**NUMBER:** 21-036-20 REV. A

Transmission Case Oil Leak

This bulletin involves tightening the lower transmission bolts to updated torque specifications to possibly eliminate a leak at the case split line of the transmission.

2019 (RU) Chrysler Pacifica

**Fig. 3**  
**Support Bracket to be Removed**

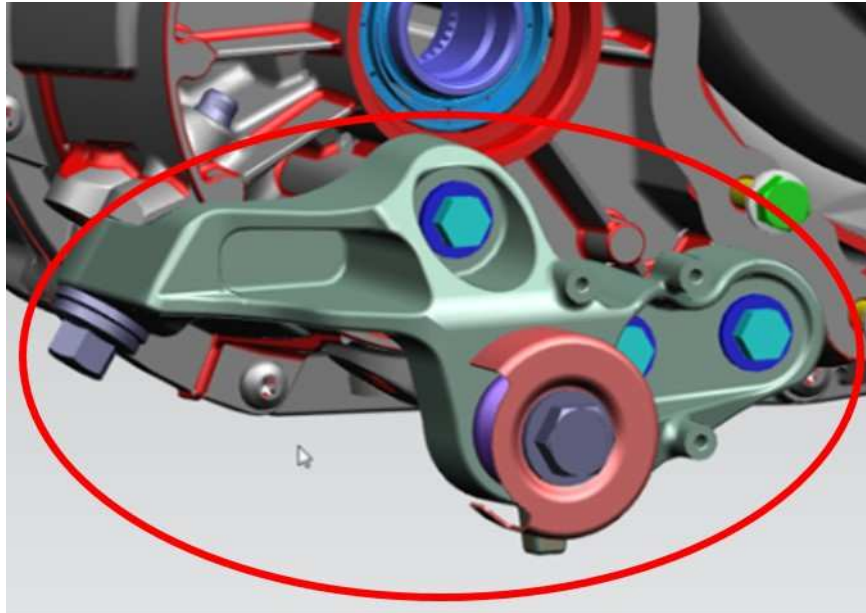
1. Remove the transmission mount bracket (Fig. 3) to gain access to bolts 1 & 2 (Fig. 4) .

Fig. 4

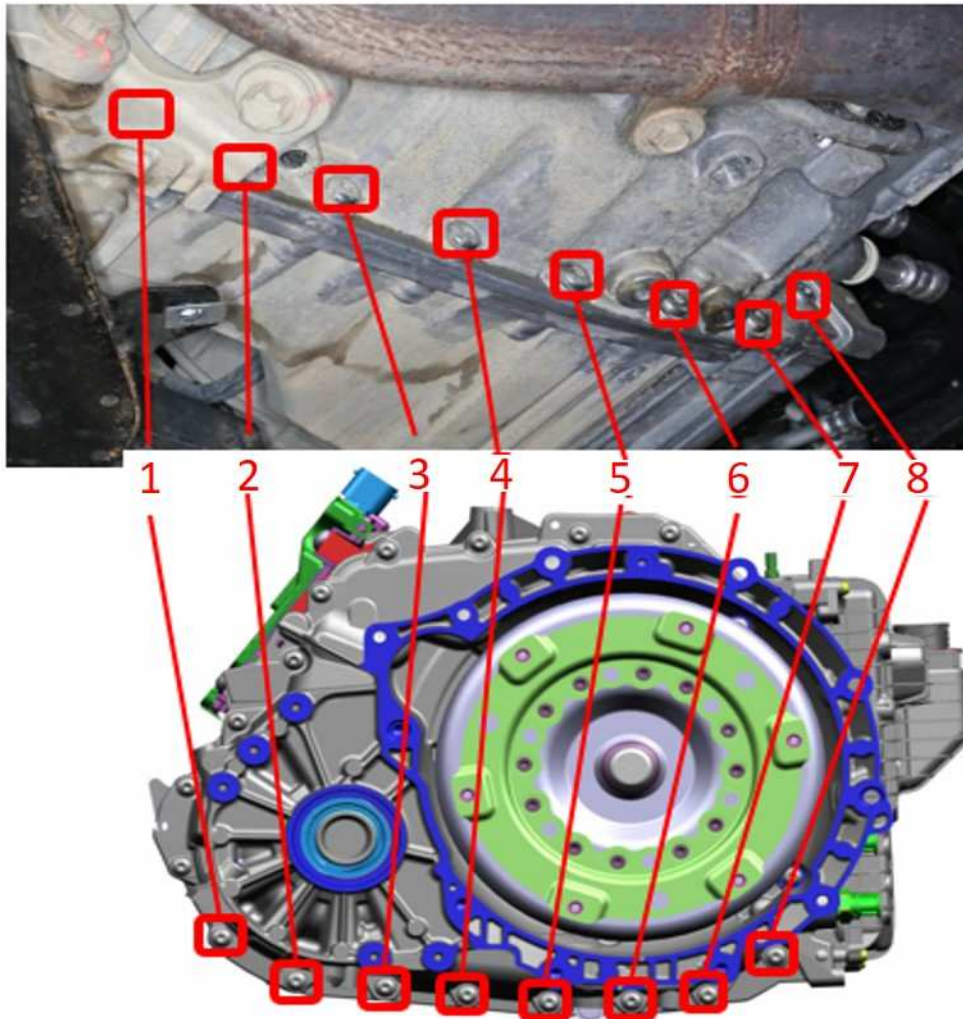
2. Starting at bolt #8 and then working to bolt #1, torque bolts to 35 N·m (26 ft. lbs.) (Fig. 4) .

**CAUTION! Do not rotate the bolts counter clockwise.**
